NOTICE AND AGENDA BRIGHAM CITY PLANNING COMMISSION

**BRIGHAM CITY, UTAH
PLANNING COMMISSION
STAFF EVALUATION**

APPLICANT: Colin Jube and Andrew Laing
PROPERTY OWNER: BC Fuel Center Holding LLC
PROPERTY ADDRESS: 1560 North 2400 West
PARCEL NO.: 03-074-0055 (Portio of **03-074-0017)

Permitted Use Permit – Fuel center, convenient store, and quick-service restaurant

1
E102
SITE PHOTMETRIC PLAN
1" = 20'-0"

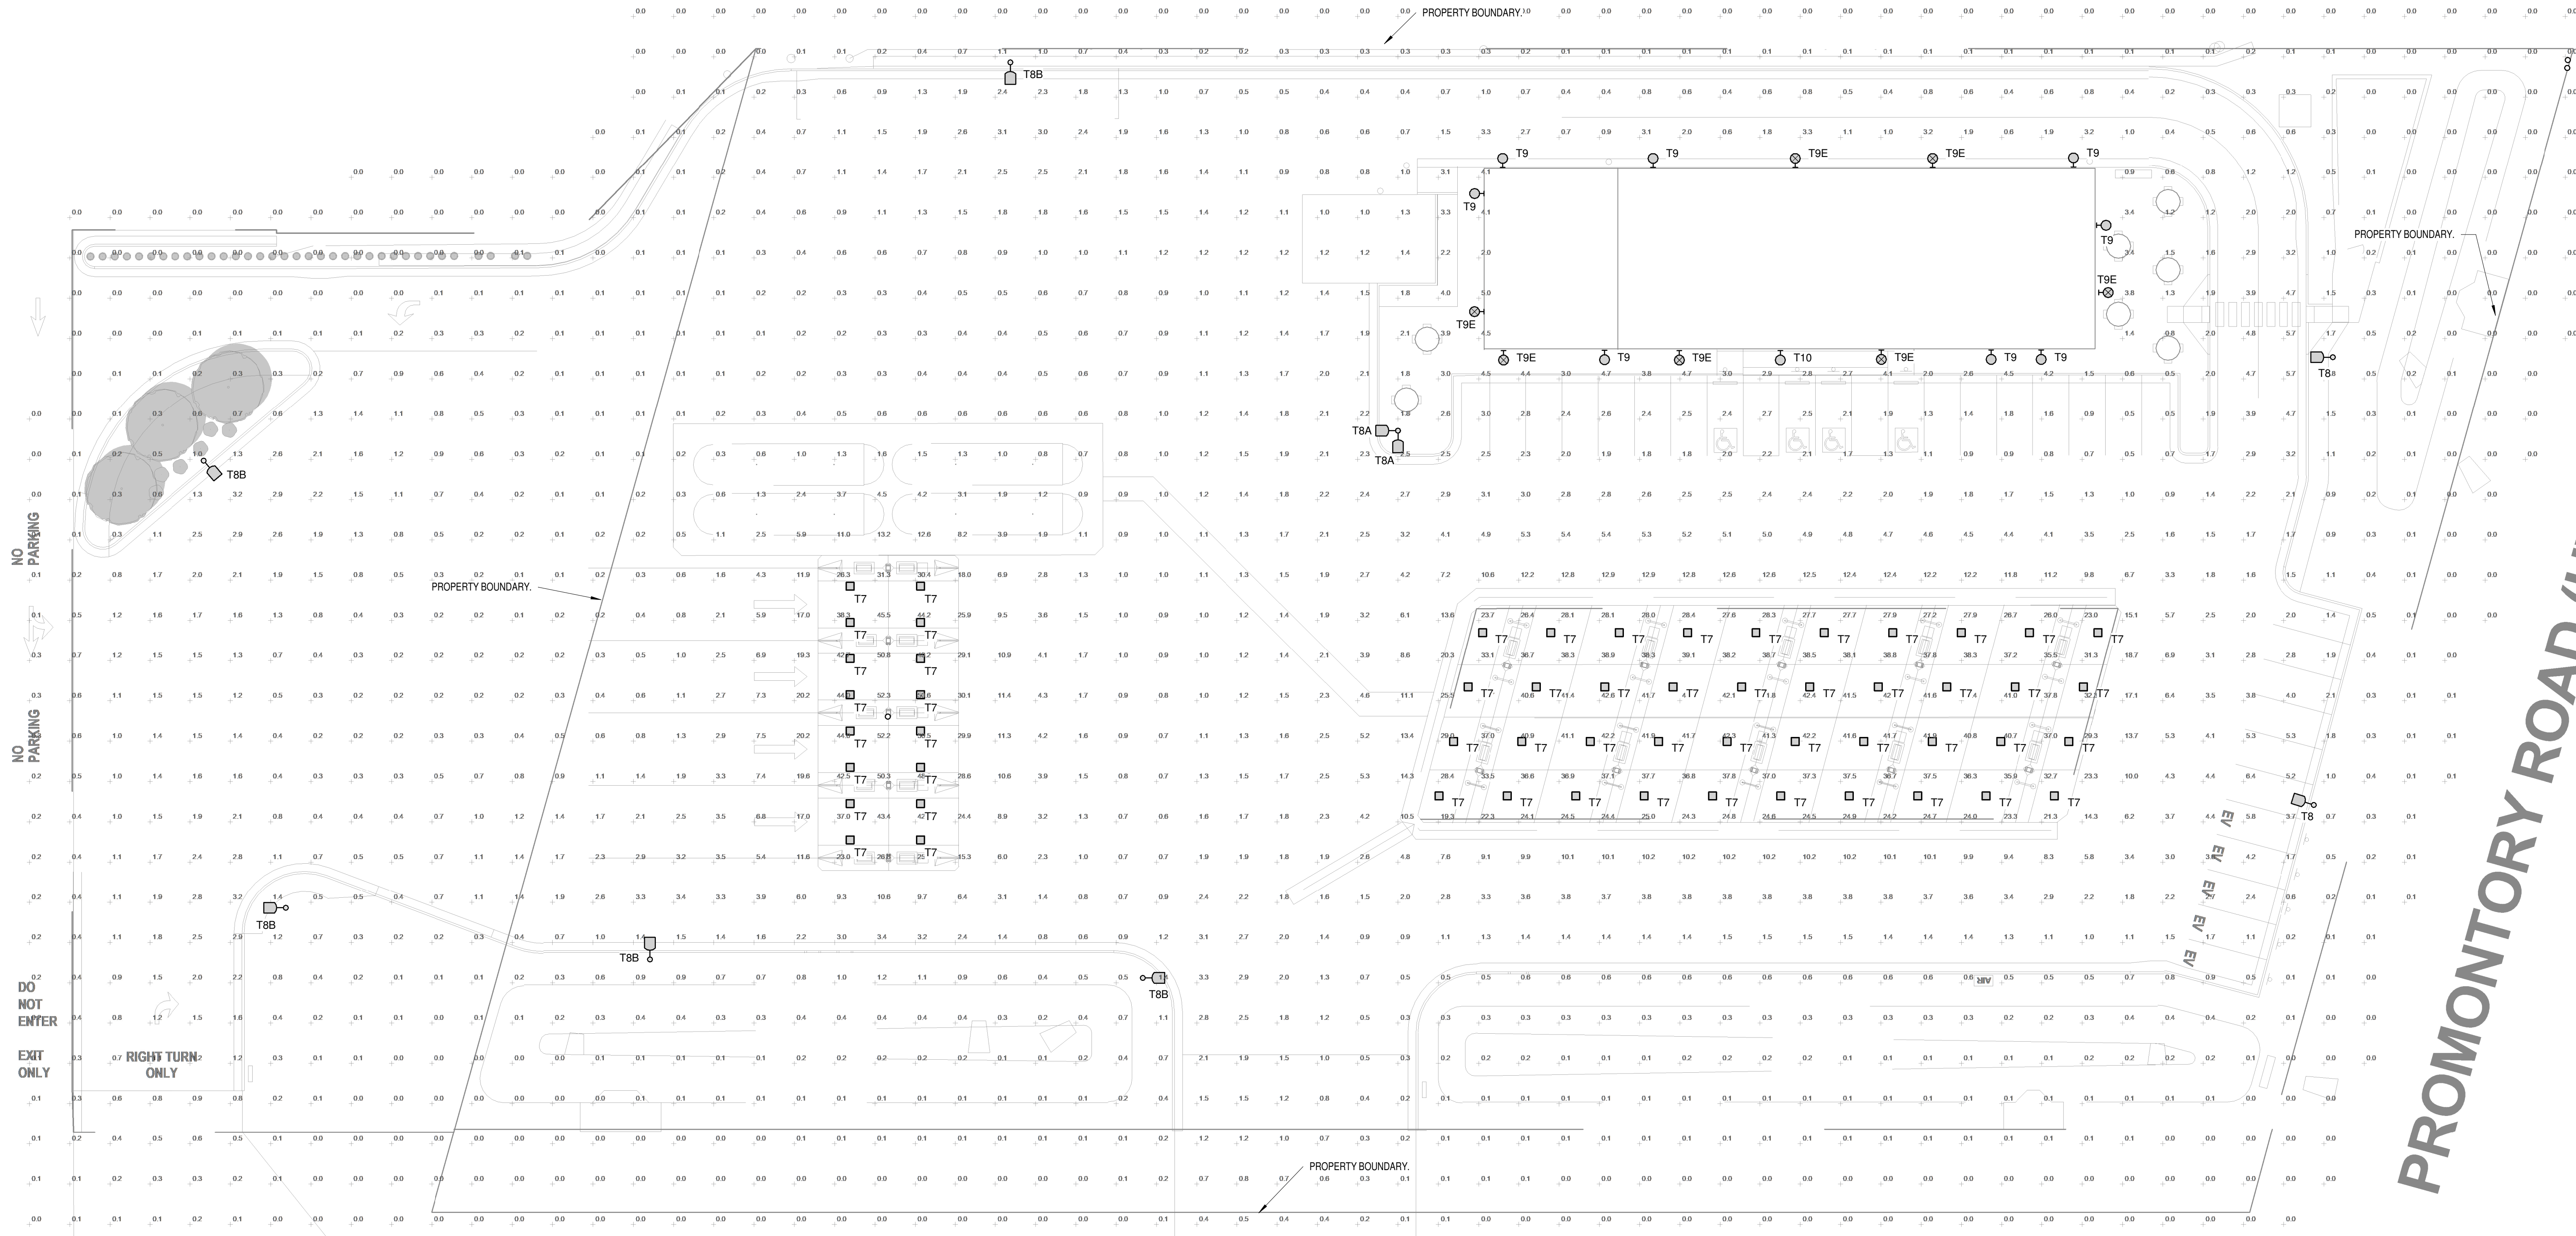
- 8. Outdoor Lighting Plan. Please update and address. See attached City Code 156.361.
 - A. Include reference that all lighting will be fully shielded.

- B. Include support and shield.
 - C. Provide canopy example.
 - D. Provide samples of light fixtures.
 - E. Provide height of all outdoor lighting fixtures.

- F. Provide a light calculation that shows the total lumens output.
- 9. Canopy Elevations.
 - A. Provide canopy elevations.
 - B. Will there be a canopy structure for the semi-truck fueling area?
